RE: **Pinnacle Bellevue North**
Project #: 21-103195-LD; 21-103192-LP
Revision Request #2

#21-103195-LD – DESIGN REVIEW

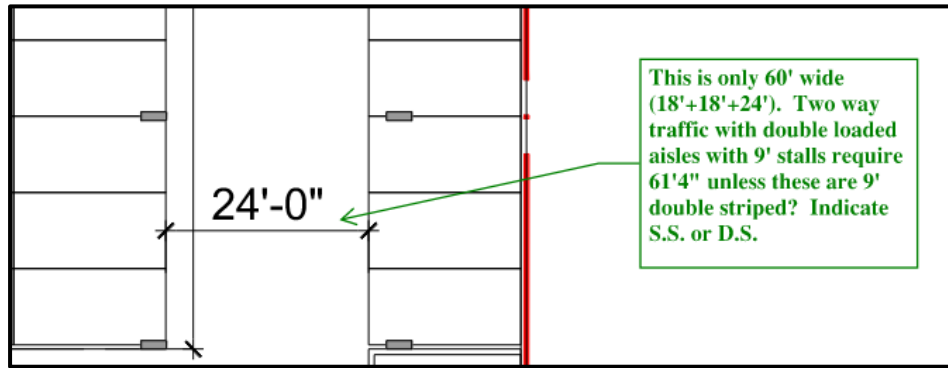
- Refer to comments below regarding active uses at the upper level and below grade.
- Points of interest do not necessarily have to be on a building façade. Refer to definition below for ideas. Provide some points of interest on each of these rights-of-ways. A departure to eliminate all of them is not acceptable when there are other ways to achieve points of interest outside of the building façade design.

DT – *Points of Interest*: Elements of a building's façade at the street level or in the streetscape that contribute to the active enrichment of the pedestrian realm and design character of a building. Some examples include permanent public artwork, architectural elements, landscape features, special walkway treatments, such as pavement mosaic and inlaid art, and seating areas.

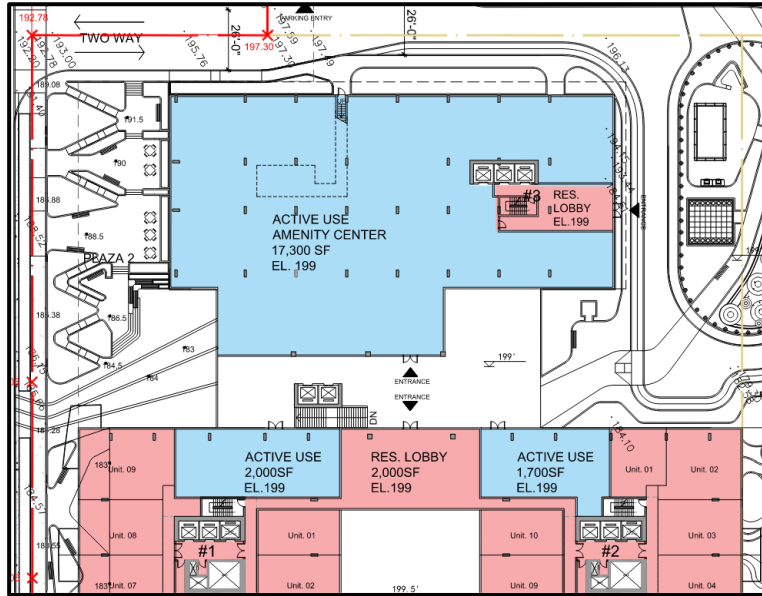
4. Sheet A0.52: The areas in blue on level F2 are indicating active use areas, but these cannot be considered exempt FAR if they don't meet the definition of active use and if they don't meet the criteria for upper-level active uses, which require a visual and physical connection to the public sidewalk. Refer to <https://bellevue.municipal.codes/LUC/20.25A.170.D> for development standards for upper-level active uses.

Provide additional information on what these uses are going to be, and show how these comply with upper-level active use standards to be exempt FAR. The entry vestibule into the market shows a stairwell and elevator, but this does not meet the development standards for accessing upper-level active uses. It must be exterior to the building.

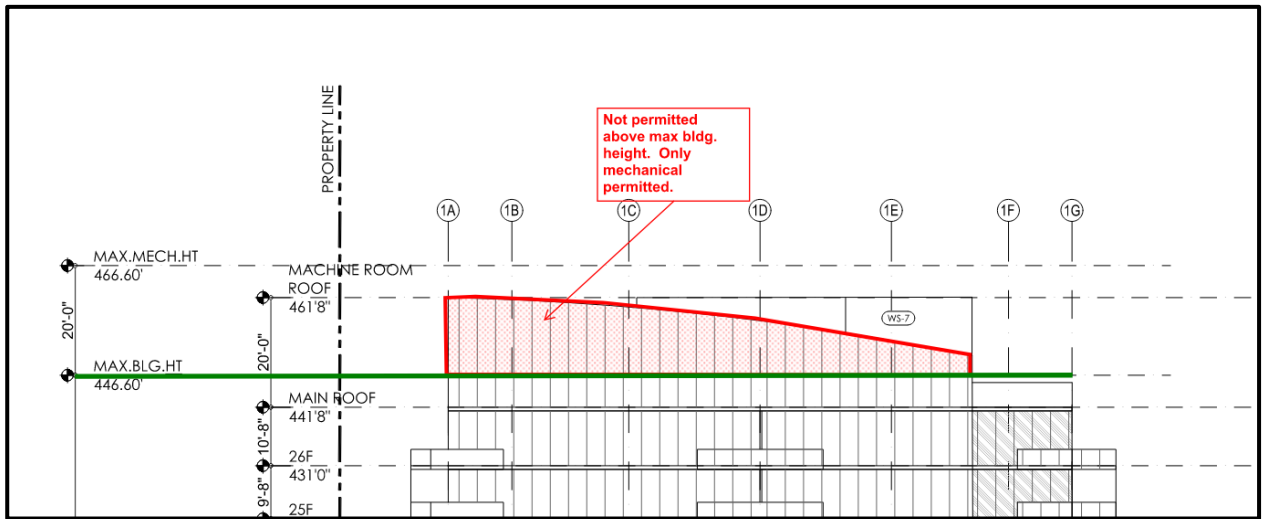
DT – Active Uses: Those uses listed in LUC [20.25A.050](#) under “Cultural, Entertainment and Recreation,” “Wholesale and Retail” (with the exception of [recycling centers](#) and [gas stations](#)), and “Services” (limited to finance, insurance, real estate services; barber and beauty shops; photography studios; shoe [repair](#); and travel agencies). Those uses listed in LUC [20.25A.050](#) under “Residential” (including entrance lobbies and private indoor amenity space), “Services” (except those uses listed above), “Transportation and Utilities,” and “Resources” are not considered Active Uses, but may be determined to meet the definition for an Active Use through an Administrative Departure pursuant to LUC [20.25A.030.D.1](#) and [20.25A.070.C.1.c](#). An Active Use shall meet the design criteria in the FAR Exemption for Ground Level and Upper-Level Active Uses in LUC [20.25A.070.C.1](#) and the design guidelines for the applicable right-of-way designation in LUC [20.25A.170.B](#).
